Tender Queries

City College Plymouth

T-Level Improvements

Queries 88/ 88E from Contractors.

Ground Floor Demolition Plan
1:50 @ A0

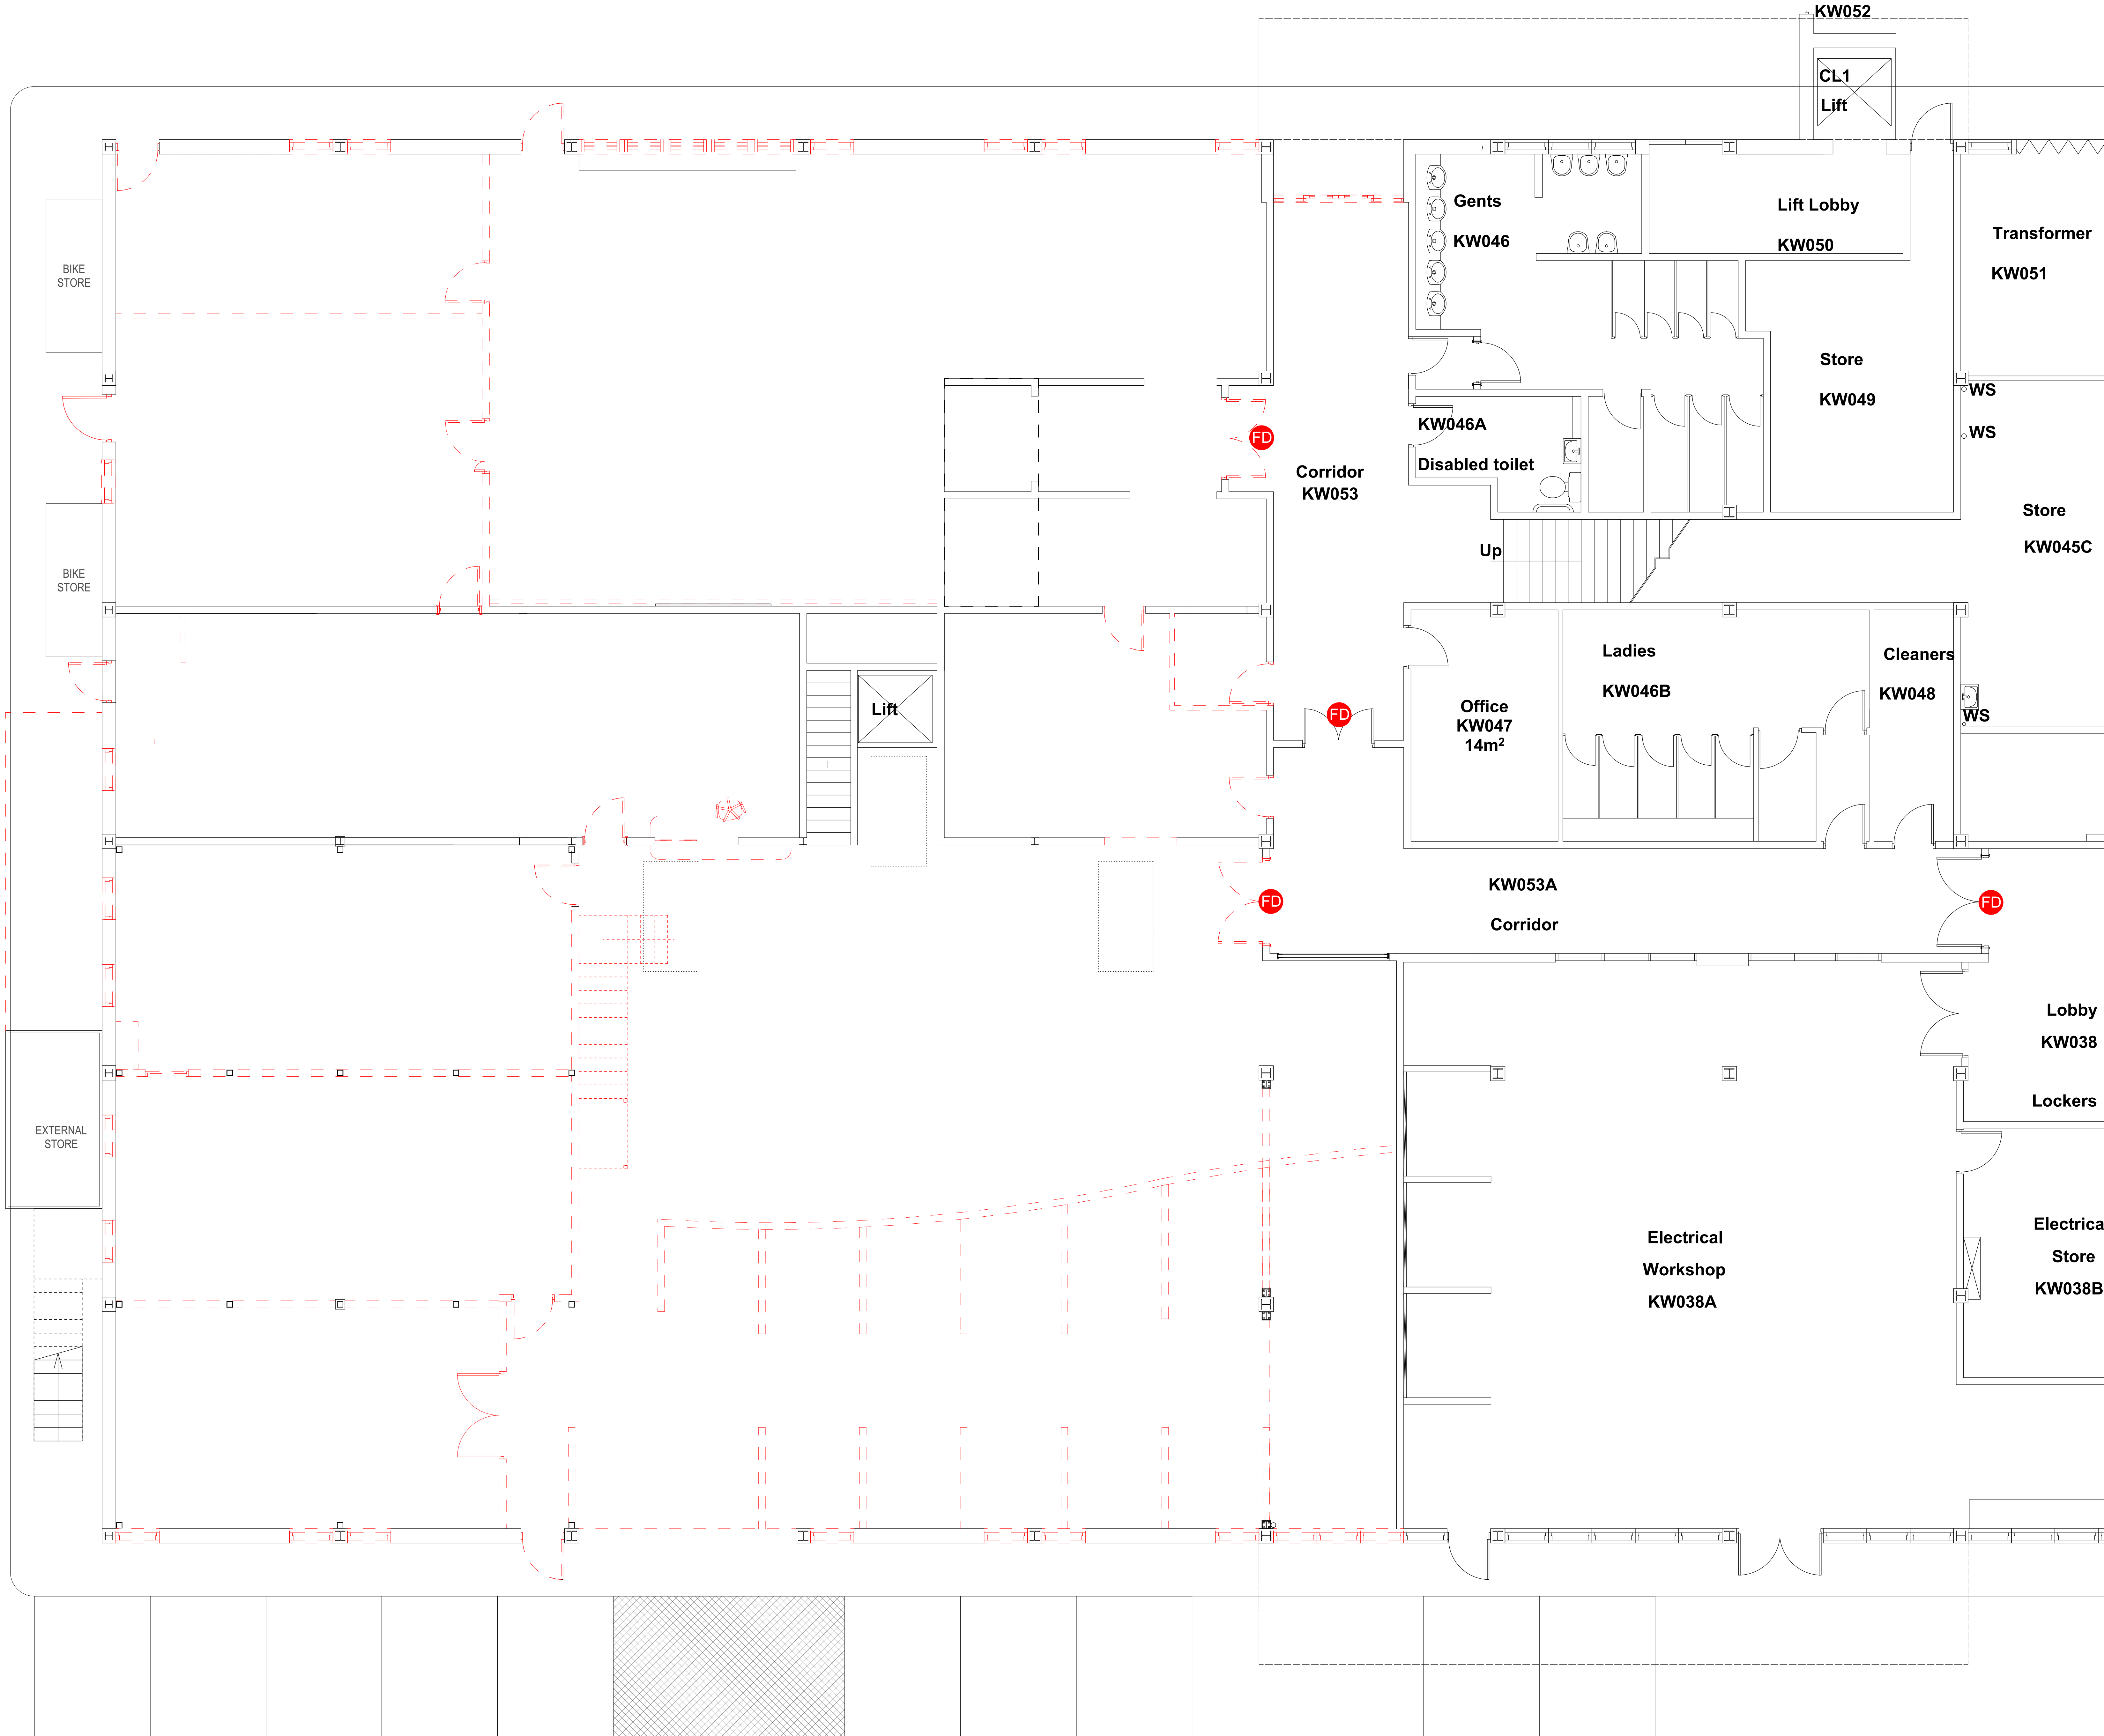
Ref	Description	KKL Comment
A	Query - do red lines show demolition items - Not On Key ?	Red dotted lines are demolition lines
B	NB - Spec refers to Demolition Drawing AL (0) 03 - Not issued ? Query demo on 01b in red ink ?	See demolition drawing 210387 AL(0)03 & AL(0)04 in appendix A; previously not included.
C	Drawing shows in Workshop 1 the partitions to be removed assumed - BUT Drawing 05C says provide opening in query existing partition as does Works Schedule 3.07.2	Partition wall between workshop 1 and workshop 2 is to be retained with a new opening provided as per Works Schedule 3.07.2
D	Note - partition drawing does not identify partition types as No Colours in Key ?? query each type spec against BQ scope schedule	Printing Error, please see revised drawings 210387 AL(2)03I attached in Appendix A

Project Number: 210387-AL(2)03 I

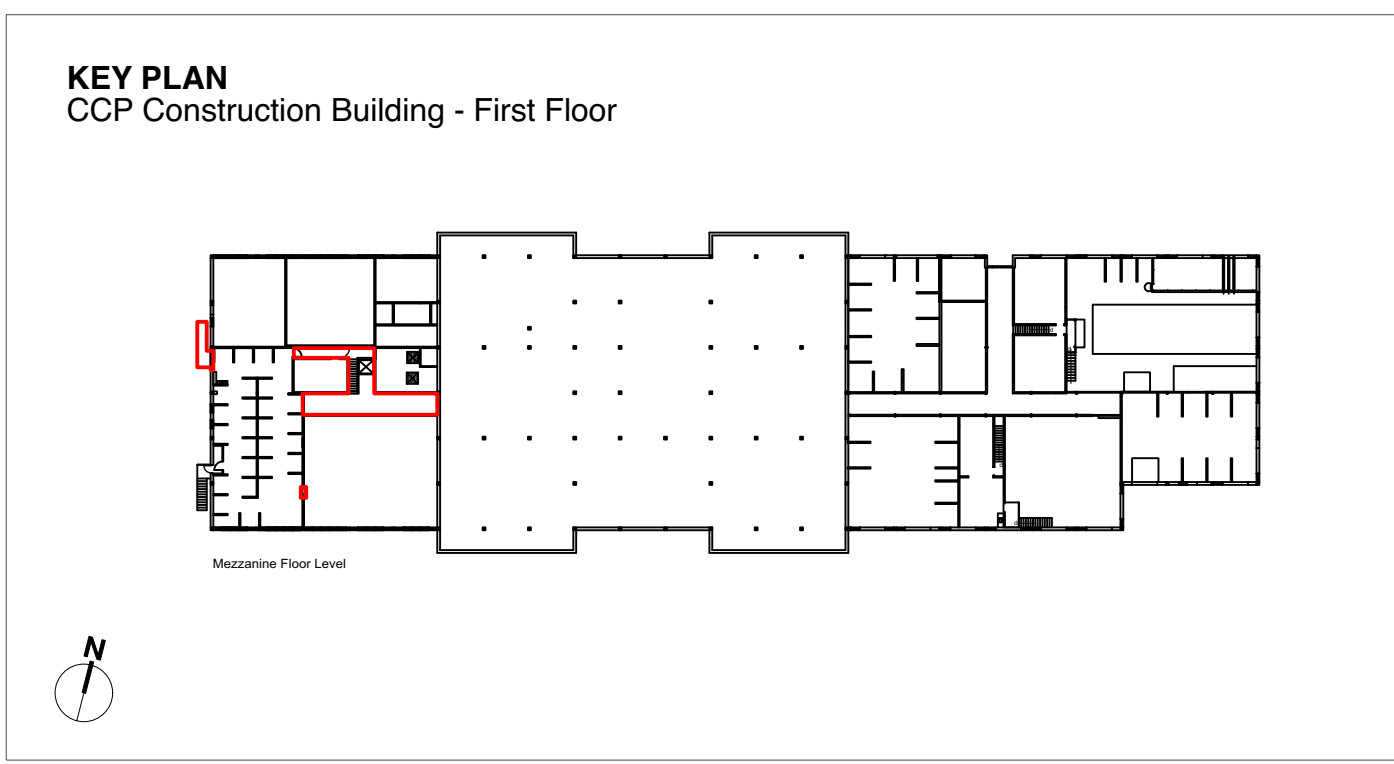
Ref	Description	KKL Comment
F	See partition type Key Colour code comment above and spec types (Note printing colour error) - query partition 1st floor	Note as above - Printing Error, please see revised drawing AL(2)03I attached in Appendix A.
G	ADD Sink Units type1A in Workshops 4 and 3, and cupboard in Workshop 3 - Query as Howdens scope for Clause 9.01 Common Room Tea Point ??	Common room tea point to Works Section 9.01. Tool storage cupboard in workshop 3 is client supplied. Allow same for tender purposes. Note workshop 4 and 3 items are a CDP item.
H	CoatHookspecN10/240A= Blinds-?	Contractor to submit proposals.
I	Existing Hatch to be infilled - Drawing 10B	See works section 5.08
J	Work shop 2 - query decorations make good new opening / window replacements	Include for making good to new openings and any window replacement.
K	Confirm External Bottle store size as Elevation ? Item 7	Confirm size as per drawing 210383 AL(2)17D as attached in Appendix A

210387-AL(2)04 C

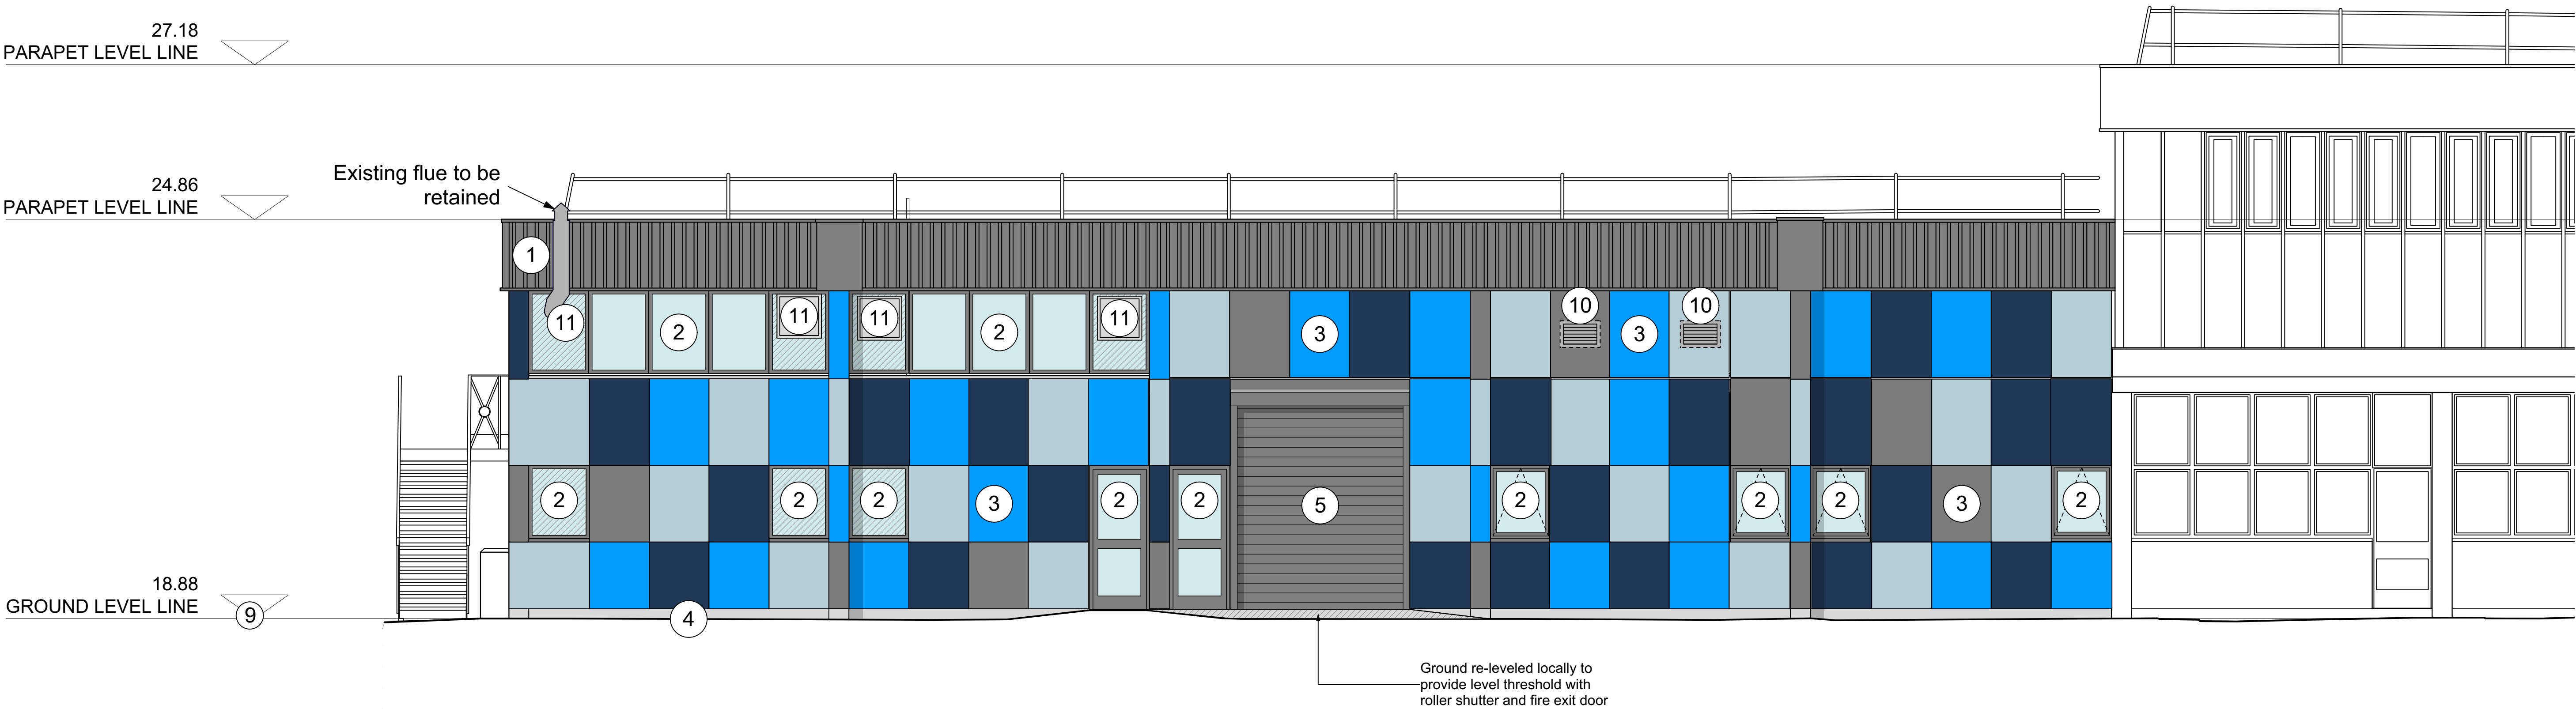
L	Query 1st Floor door removal / infill to void to ex stair landing query being removed ? SV ? - Drawing 04B	Printing Error, please see revised drawing AL(2)04 to show new fire door attached in Appendix A.

Drawing Title
Proposed South East Elevation

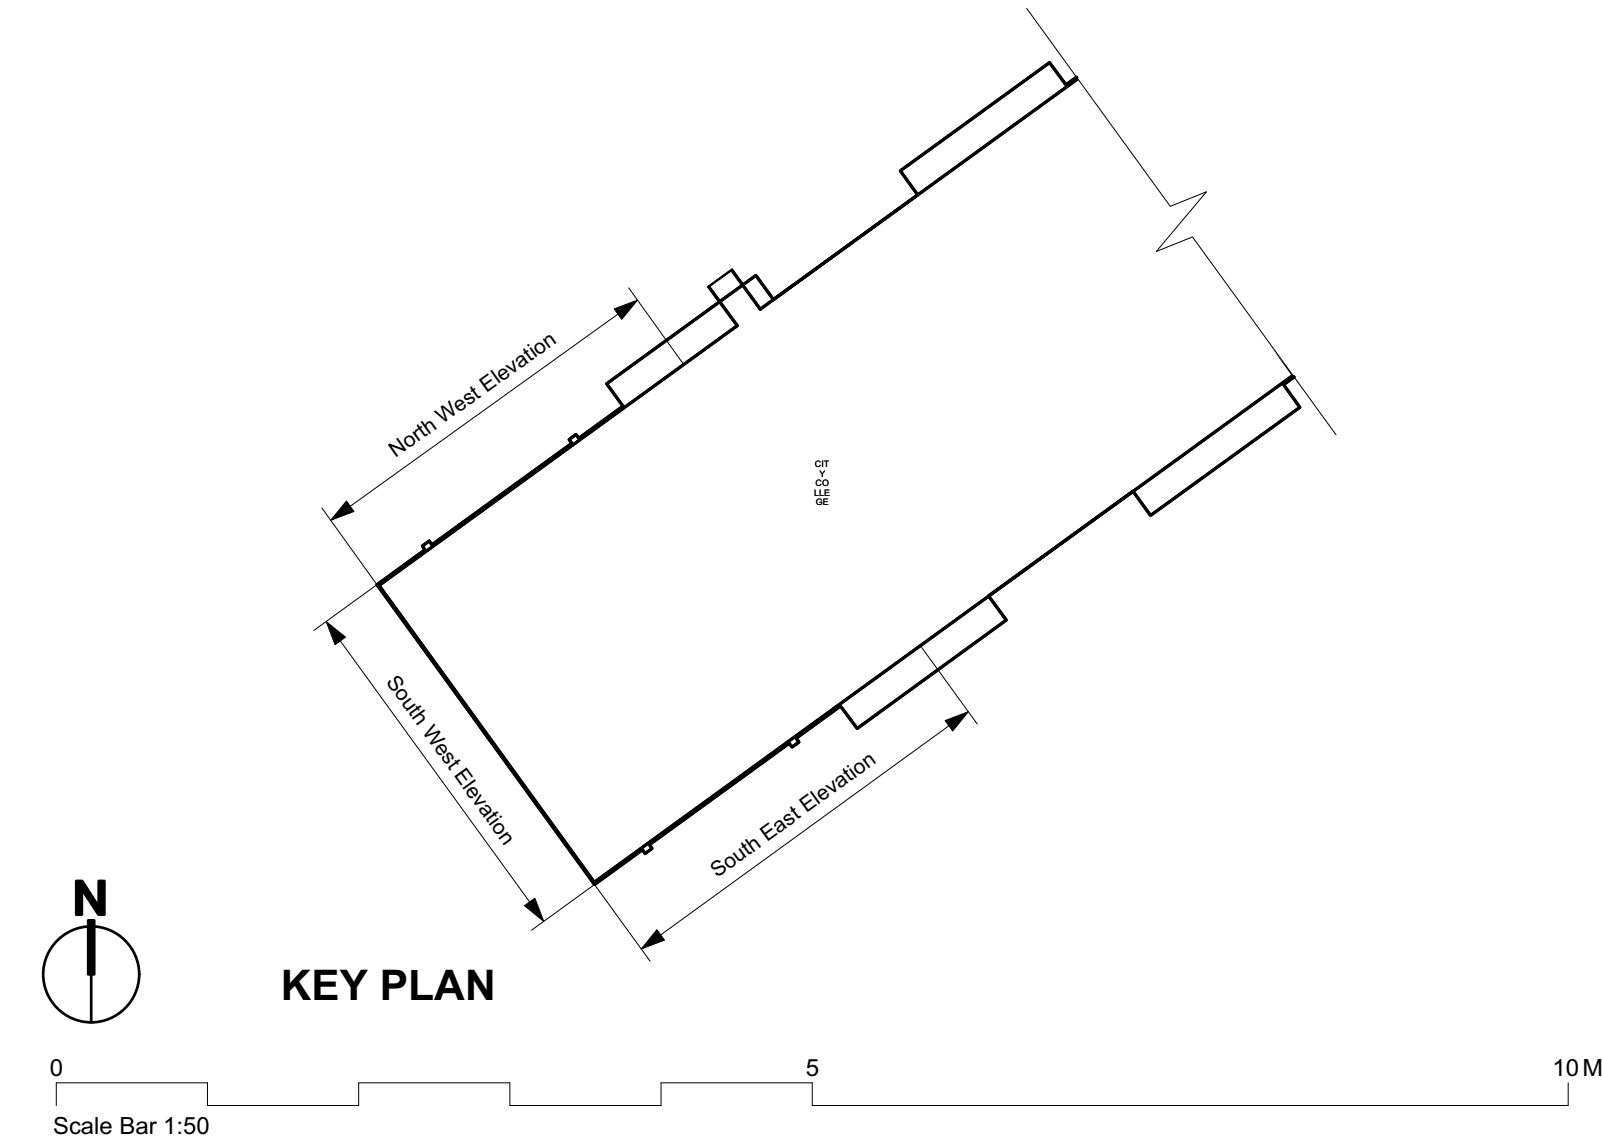
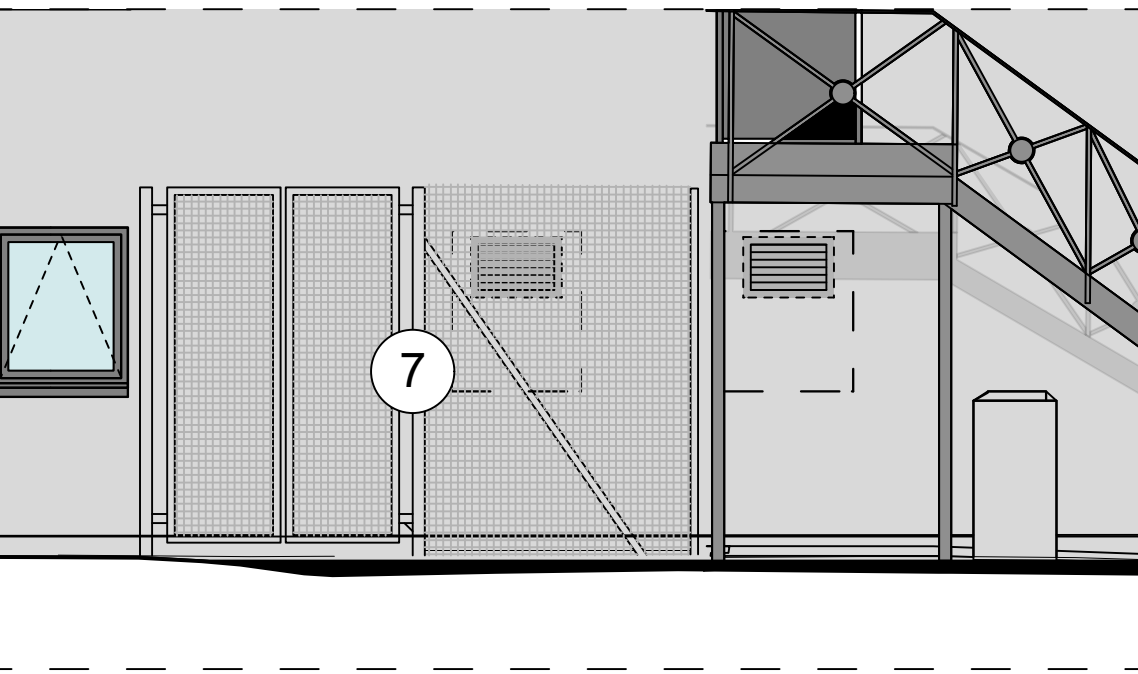
Ref	Description	KKL Comment
A	The 3 windows adjacent the Electrical Workshop KW038A are not shown for replacement - see Drawing AL (2) 01B)	Price as shown for tender purposes.
B	Query - high level windows to 2 bays replaced (Item 2 ?) - the 3 other bays are overclad	Correct
C	Note Drawing AL (2) 01B does not show the roller door / access door opening for demolition	Please see drawing 210387 AL(0)03 in Appendix A
